**PLANNING COMMISSION-CITIZEN ADVISORY COMMITTEE
CITY OF LOWELL, MICHIGAN
AGENDA**

**FOR THE REGULAR MEETING OF
MONDAY, AUGUST 12, 2019 AT 7:00 P.M.**

RiverView Flats

To: City of Lowell Planning Commission
Date: August 6, 2019
From: Andy Moore, AICP
Whitney Newberry
RE: Riverview Flats – Parking Review

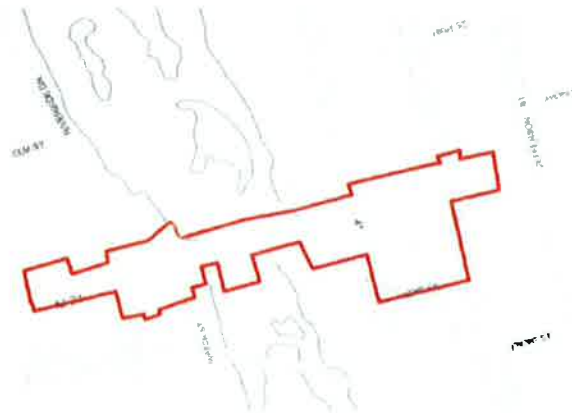
- Site Plan Revisions: The Commission asked the applicant to update the site plan to show desired pedestrian connections. This was provided by the applicant shortly after the meeting and is included with your packets.
- Historic District: The project is not within Lowell’s Historic District. (see map below)

- Review by Township Engineer: Dave Austin, PE of our office reviewed the plans and offers the following comments for your consideration:
 - Water – The development will connect to an existing 6-inch line on King Street and an existing 4-inch line on Monroe Street. The 4-inch line is programmed for replacement with an 8-inch line in the future, along with street improvements on Monroe. This is not yet scheduled, but the developer should coordinate with the City before finalizing plans to connect to the 4-inch line in order to plan ahead for the transition to the new line.
 - Sanitary Sewer – The proposed connection is by gravity to the existing 12-inch line in Monroe. No new sewer work is planned for this area. The proposed connection should be acceptable.

- Storm Sewer – On Sheet C2.0, Note 9 states, “As the site is riparian and within a floodplain, stormwater management goals of the project focus on providing stormwater quality improvements and maintaining onsite grading characteristics to provide storage for impending flood conditions.” Since the site has a direct discharge to the Flat River, we concur with the stated intent, but do not see anything on the plans that shows specific stormwater quality Best Management Practices (BMPs). These should be presented for review by the City. The City typically uses the Kent County standards for stormwater management.
